Amendments to the Drawings:

Attachment: Replacement Sheets "3/4" and "4/4".

FIG. 5*FIG. 6*

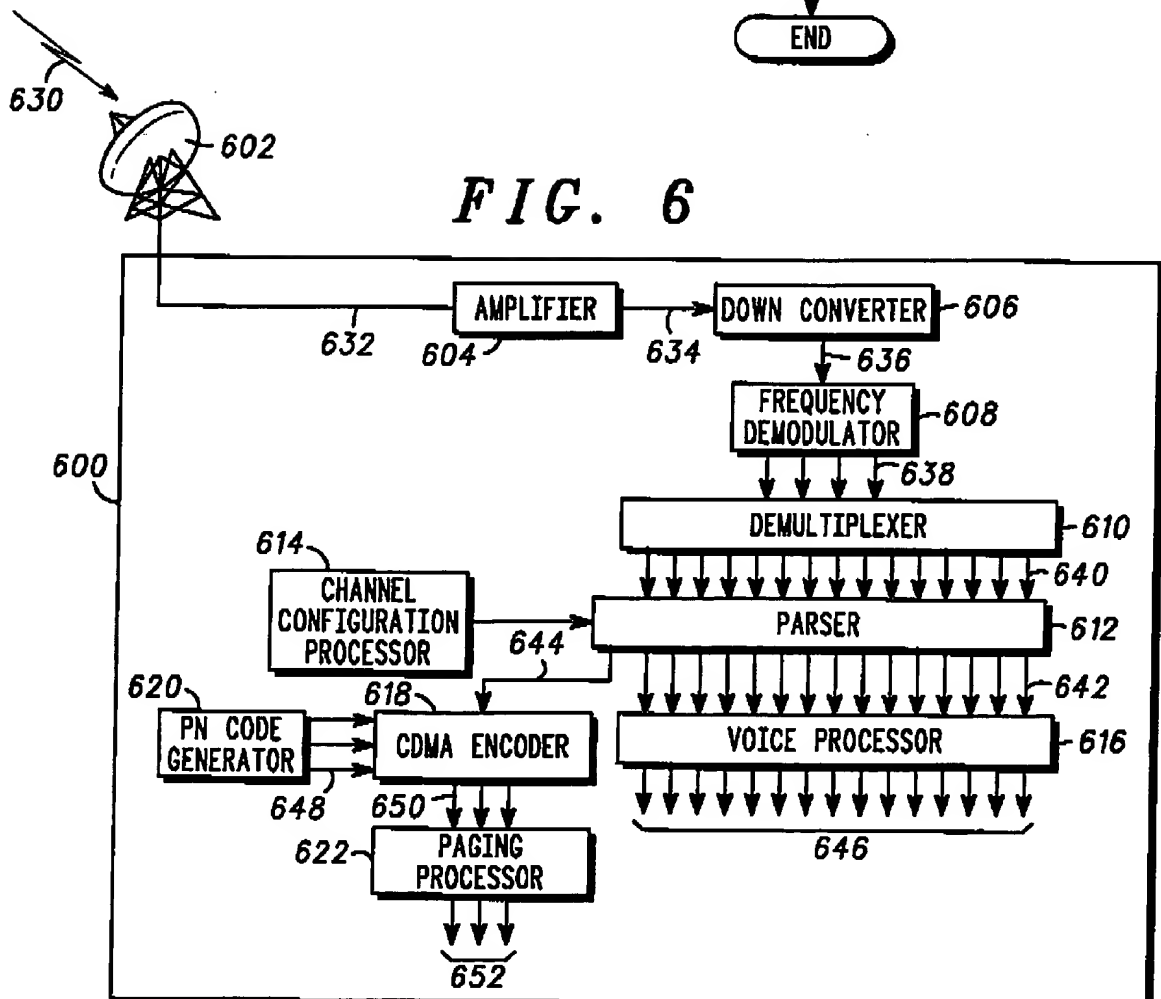
The attached sheets of drawings include changes to FIGS. 6 and 7 as required by the Examiner. More specifically, Applicant has amended FIG. 6 to clarify that element 608 is a "frequency demodulator", and has amended FIG. 7 to clarify that step 704 now recites "frequency demodulate data". These sheets, which include FIGS. 5-7, replace the original sheets including FIGS. 5-7.
